**PREPARED FOR THE BOARD OF COMMISSIONERS OF PUBLIC UTILITIES OF
NEWFOUNDLAND AND LABRADOR**

In response to Newfoundland Labrador
Hydro's 2025 "Application for Capital
Expenditures for the Purchase and Installation
of Bay d'Espoir Unit 8 and Avalon
Combustion Turbine"

EXPERT REPORT OF VINCENT MUSCO AND COLLIN CAIN

June 26, 2025

Figure 1: Build Application comparison of 2023 and 2024 Load Forecasts⁴⁵

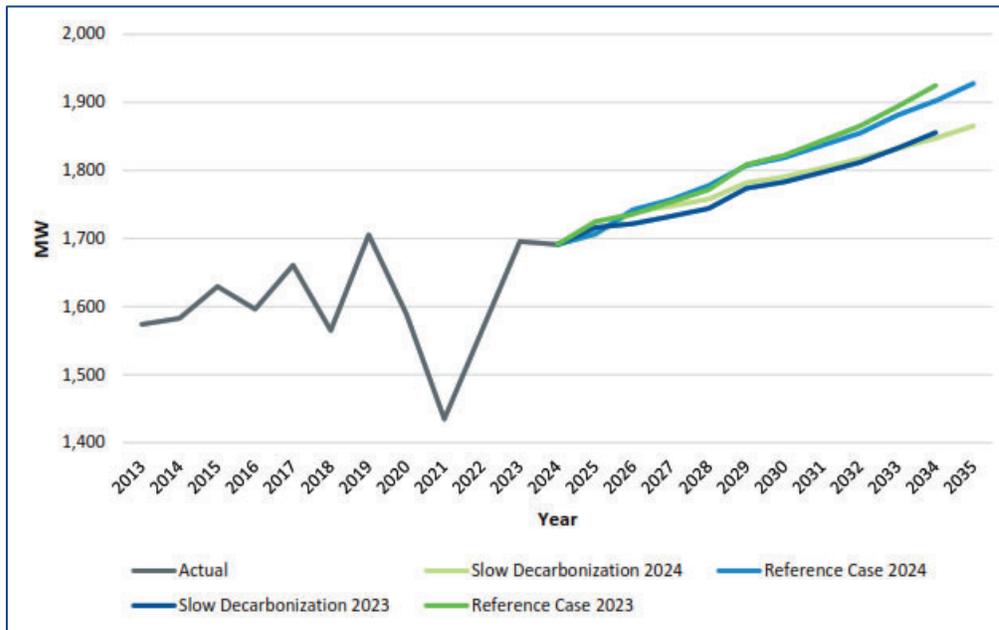
- (32) Figure 1 reproduces Chart 1 from the 2024 Island Interconnected System Load Forecast Report (included in the Build Application as Appendix A to Schedule 3). The two lower lines on the right side of the chart are: 1) the Slow Decarbonization scenario from the 2023 Load Forecast, in dark blue, and 2) the corresponding load data from the 2024 Load Forecast, in light green. These lines appear consistent with the quoted characterizations by Hydro noted above (i.e., the 2024 Load forecast is lower overall as of 2034, affected timing of the resource selection in that year, but very slightly higher in 2032, affecting the LIL Shortfall Analysis). However, the numerical data provided in the two referenced load forecast reports differ slightly, but noticeably, from the values reflected in Chart 1 of the 2024 Load Forecast Report. The difference is shown by comparison to Figure 2, which plots the numerical data provided in the two load forecast reports.

Figure 2: Slow Decarbonization load forecast comparison from forecast report data tables⁴⁶

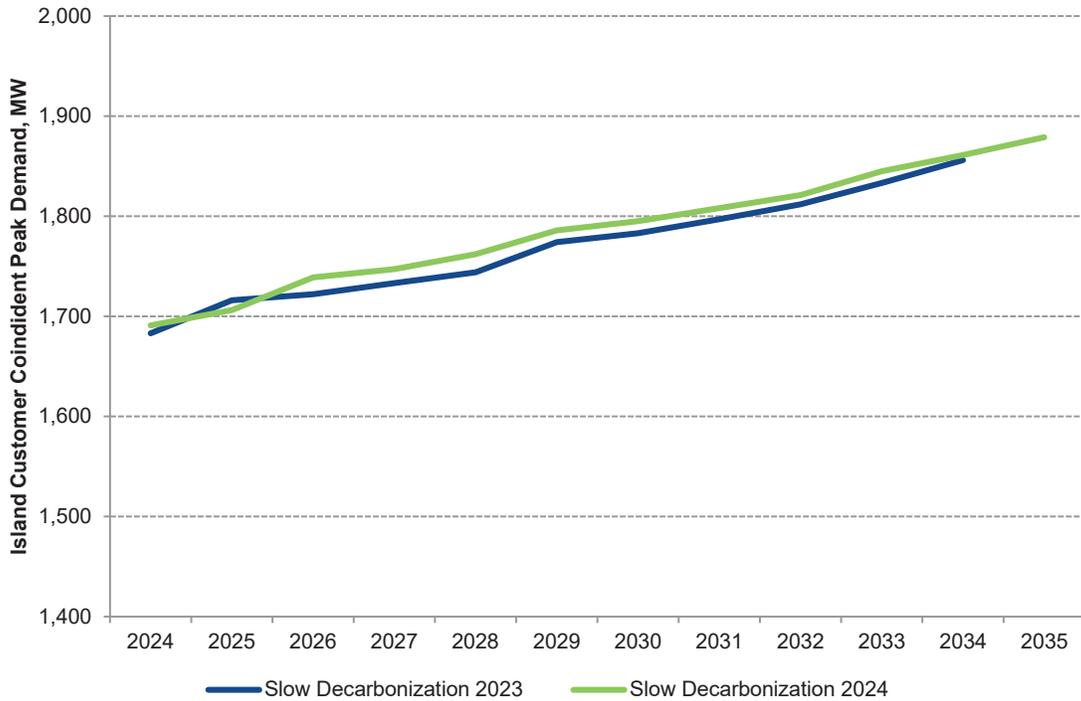
- (33) The numerical data, graphed in Figure 2, indicate that Slow Decarbonization scenario is slightly *higher* in the 2024 Load Forecast than the corresponding case from the 2023 Load Forecast. The data show that demand is approximately 5 MW higher in 2034 rather than 8 MW lower, as described in the Build Application. It is not clear which is correct, nor what data were actually incorporated in the expansion plan modeling supporting the Build Application.
- (34) As discussed above, we find the more significant issue is that the load forecasting is uncertain, it changes year-to-year, and even relatively small changes produce significant changes in the expansion plan modeling. For this reason, we find that close monitoring of load trends is essential to determine what future path actually is more likely going forward.

Figure 3: Estimated Annual Capital Cost of Operating Holyrood TGS (2025-2035)¹²⁶

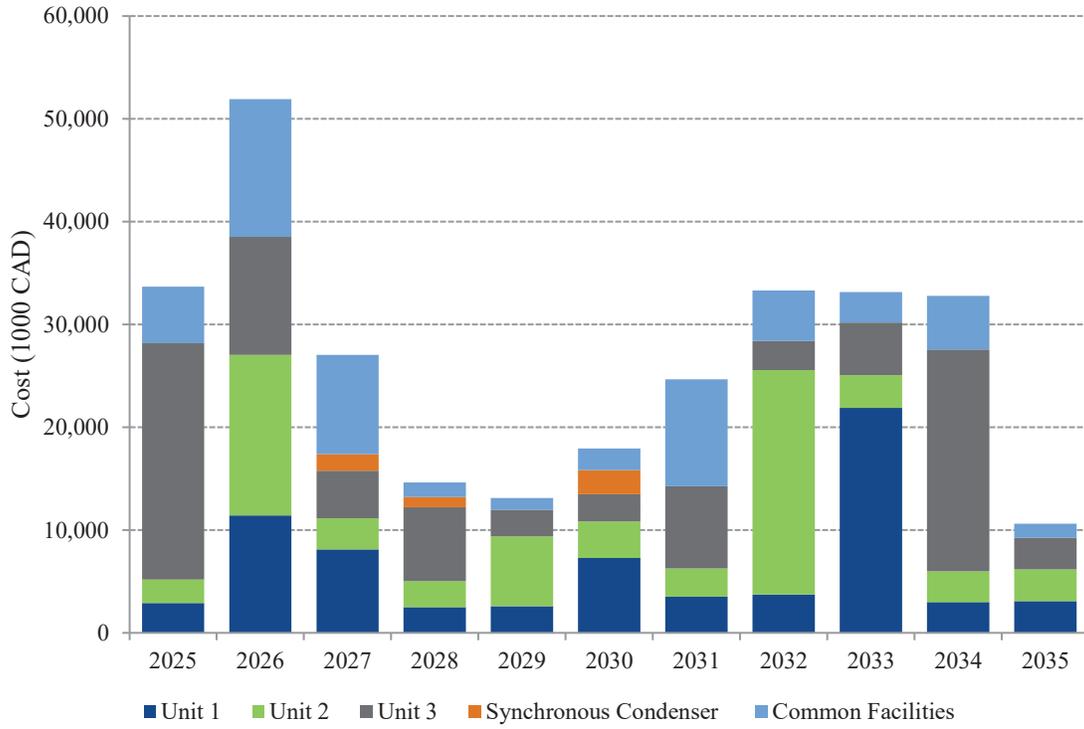
- (67) Hydro will also need to manage its capital investment in the Holyrood TGS facility as its planned retirement date nears. To avoid stranded investment at asset retirement, Hydro will seek to reduce capital expenditures at Holyrood TGS as the retirement date approaches. However, if retirement dates are delayed, additional capital expenditures may be needed to keep the units reliable. If retirement dates are uncertain, Hydro will need to balance the risk of underinvesting in its existing assets that may be needed longer than expected against overinvesting in assets about to retire. The figure below demonstrates Hydro's current plan for capital investments, by unit, through 2035 should the retirement date be so delayed. Note that capital investment starts a decreasing trend in 2026 through the planned retirement year (2030), then ramps back up as the plant is sustained through 2034, before again falling in the final year into retirement (2035).

(68) All this suggests a few key conclusions. First, any delay in new generating resources reaching commercial operations in a timely manner will have costs that must include the capital, operating, and fuel costs at Hydro’s existing thermal generators. Second, and similarly, high and/or volatile equivalent forced outage rates on the LIL will also cause similar costs. Third, given the potential for delayed retirement dates, Hydro will need to develop a plan for managing its capital investments in its thermal generating assets as retirement dates approach.

Figure 4: Bay d’Espoir capacity vs. BDE-SOP eastward transfer limits¹⁵⁵

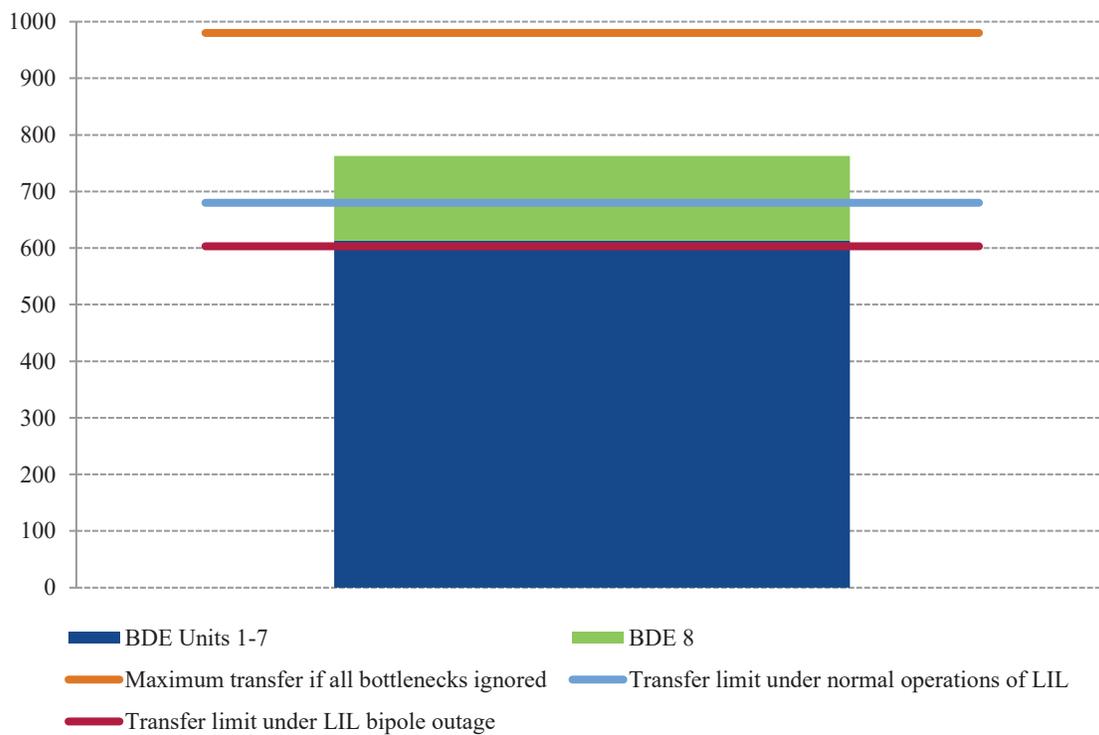
- (77) We explored this issue in additional detail with Hydro. Hydro explained that, if all single contingency events were ignored, the limit for eastward flow across BDE-SOP would be 980 MW.¹⁵² This would be sufficient transfer capacity to deliver 100% of Bay d’Espoir’s maximum generation (763 MW) – including that from BDE Unit 8 – east to the Avalon. However, in considering single contingencies with the LIL in service, the maximum eastward flow on BDE-SOP is 680 MW under normal operating conditions.¹⁵³ This limit is further reduced to 603 MW during a LIL bipole outage.¹⁵⁴

- (78) The implication of this data is that the current, unmitigated BDE-SOP constraint prevents Hydro from delivering all of the incremental potential output of BDE Unit 8 during normal conditions and prevents delivery of *any* of the incremental output of BDE Unit 8 during a LIL bipole outage. This is shown in the figure below, which shows the capacity of Bay d’Espoir, broken out by units 1-7 (613 MW) and unit 8 (150 MW). The orange horizontal line at the top of the figure is the 980 MW transfer capacity of the BDE-SOP, ignoring any single contingency constraints. The blue horizontal line shows the 680 MW BDE-SOP transfer limit under normal operations with the LIL in service; this allows for delivery of up to 67 MW of incremental BDE Unit 8 output, but no more. The red horizontal line represents the transfer limit (603 MW) during a bipole outage; at this level, zero incremental output from BDE Unit 8 can be delivered.

- (79) The implication of these data is that as constituted, the BDE-SOP 230 kV system prevents transmission of *any* incremental output from BDE Unit 8 during a LIL bipole outage, exactly when that output is needed most. Even during normal operations with the LIL in service, just a fraction (67 out of 150 MW) of the incremental output from BDE Unit 8 is deliverable.

- (80) Hydro has made it clear that it is exploring transmission solutions that will not only alleviate this constraint but will also restore a maximum transfer capability over BDE-SOP of 980 MW.¹⁵⁶ It must be noted, however, that the Build Application leaves unanswered the question of how this constraint will ultimately be alleviated, and at what cost. The TransGrid study was completed in October 2023, and while we agree with Hydro’s efforts to pursue transmission solutions that are alternatives to the \$150 million “least cost” transmission upgrade solution, the unresolved nature of this issue reduces confidence in BDE Unit 8 as a generation resource. As it stands, the Board has been asked to approve the development of BDE Unit 8 at a cost of \$1.08 billion, but with no clear explanation of how the transmission grid will be upgraded or managed to allow for the reliability benefits of BDE Unit 8 to accrue to the system. The TransGrid study (due by the end of the second quarter of 2025) and the results of Hydro’s dynamic line rating technology review will likely be instructive and may be

Figure 8: Implied water consumption at BDE and Long Pond storage volumes during LIL shortfall³⁰⁷

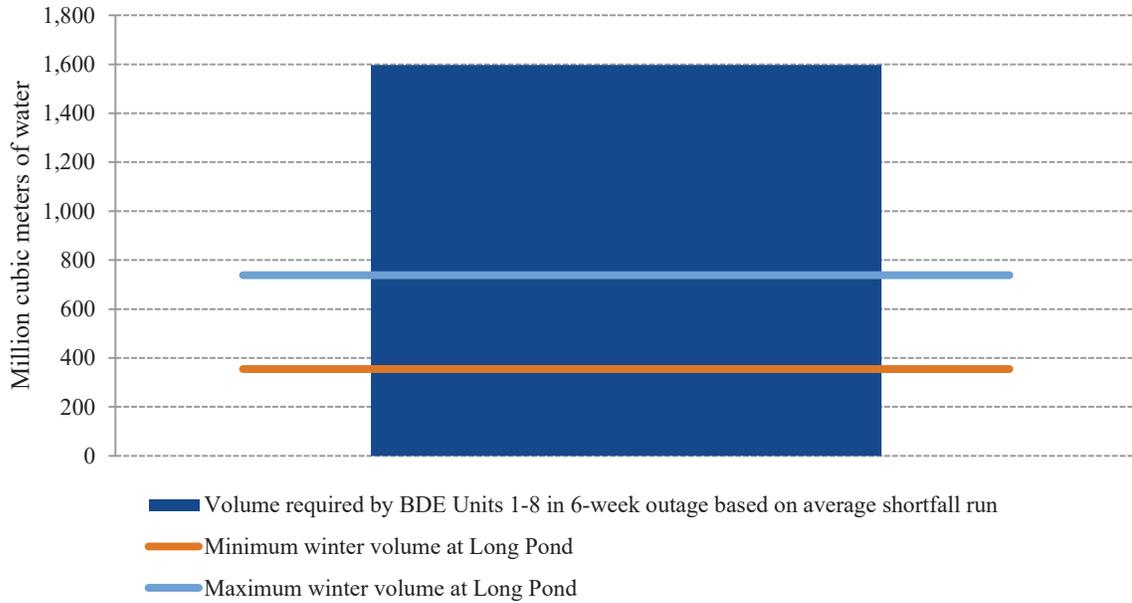
- (142) Hydro also explains that the Maximum Operating Level of the Long Pond Reservoir (which supplies Bay d’Espoir) is 738 MCM in the winter season.³⁰³ That amount is further limited by the minimum storage level of 355 MCM.³⁰⁴ This suggests that the Long Pond Reservoir would have a maximum volume of 738 MCM entering winter and could release up to 383 MCM for consumption at Bay d’Espoir, far less than the 1,597 MCM modeled to be consumed at Bay d’Espoir in the LIL Shortfall Analysis. This gap is shown below in Figure 7. Since the existing storage at Long Pond is insufficient to support Bay d’Espoir’s modeled output during a LIL shortfall, the reservoir will necessarily require substantial inflows to support modeled output at the plant. Notably, these inflows would be needed just to support the existing Bay d’Espoir units (1-7), let alone any incremental output from BDE Unit 8. Hydro has described winter as the “low inflow season”³⁰⁵ and the “dry winter period (January and February),”³⁰⁶ meaning the plant would need to tap its limited storage resources, including any supply from other reservoirs, to operate as planned.

(143) Hydro has not fully addressed this issue in detail in its Build Application. The March 2025 Hatch study (included in the Build Application)³⁰⁸ contained historical inflow data at BDE.³⁰⁹ However, that data was provided on an annual average basis which prevents assessment of seasonal inflows. In its 2024 RAP, Hydro also provided Bay d’Espoir’s average and firm energy capability given the most adverse three-year sequence of inflows in its historical record, which suggested average annual capability of 2,650 GWh and average annual firm capability of 2,096 GWh.³¹⁰ But this data, while useful, does not contain any seasonal granularity.
